ITEM FOR ENVIRONMENTAL COMMISSION AGENDA

NAME & NUMBER OF PROJECT: Mercedes Benz South Austin (SP-2021-0127C)

REQUEST: Variance request is as follows:
Request to vary from LDC 25-8-261 to allow a private driveway access point to the site through a Critical Water Quality Zone buffer.

Project Name: Mercedes Benz South Austin
Ordinance Standard: Watershed Protection Ordinance
Variance Request: **To allow a private driveway access point through a Critical Water Quality Zone buffer**

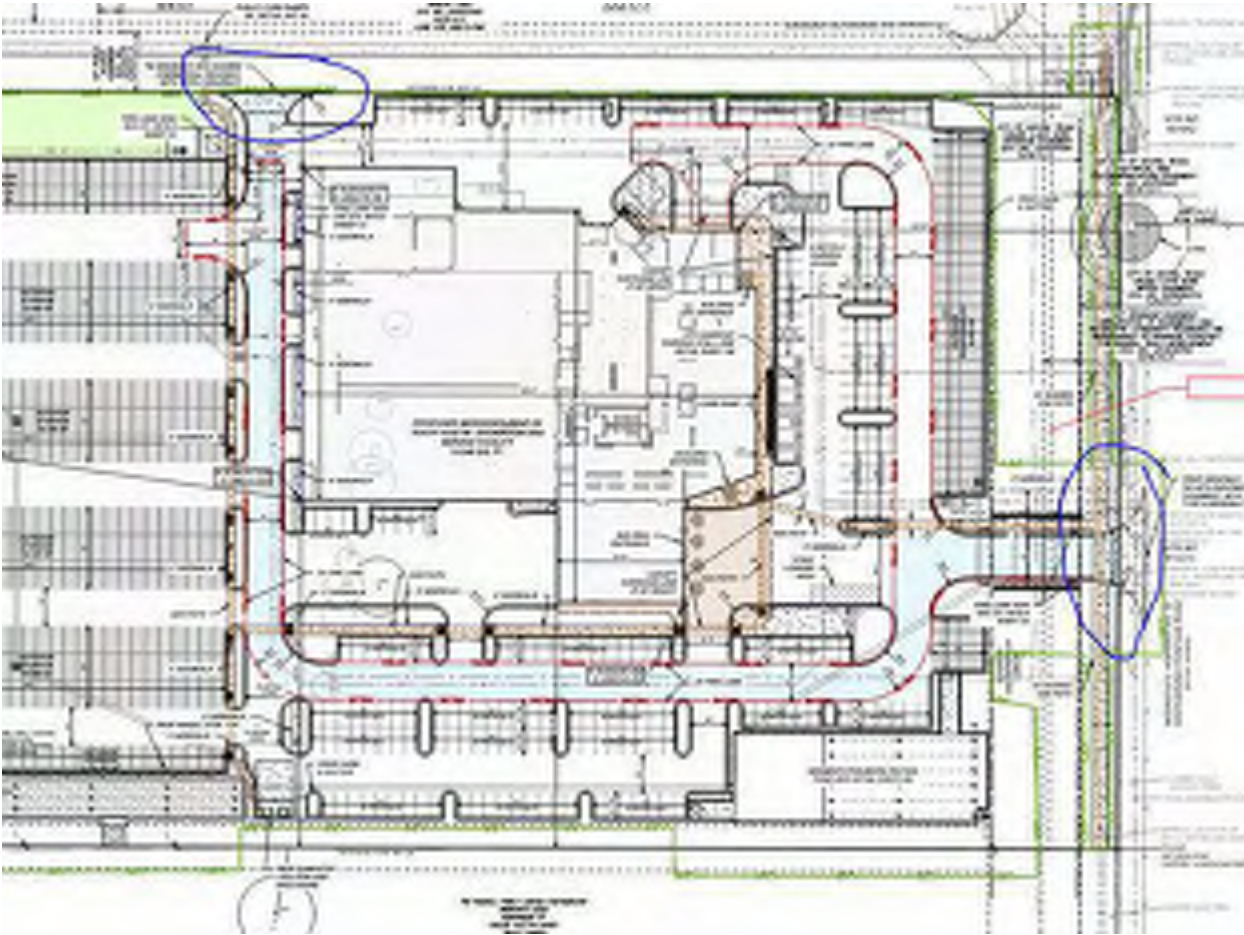
The City's GIS is showing a CWQZ on the site that we have been working through with the environmental team. We are also in a Wildland Urban Interface. The CWQZ would impact our ability to place driveways and have access to the site as shown in our plans. Would we have your support to go in front of the land use commission and receive a variance so that our site would have adequate fire access? Both the driveways shown below are currently shown within the CWQZ so we would not have two access points to the site without a variance from the Land Use Commission.

Fire department access and pathways for means of egress have specific minimum regulations in the 2015 *International Fire Code*. Eliminating the access points and means of egress pathways will require AFD to change the project status to Not Approved. AFD will not allow the construction of this or any other buildings without the required access for emergency responders and required pathways for means of egress for persons using this site.
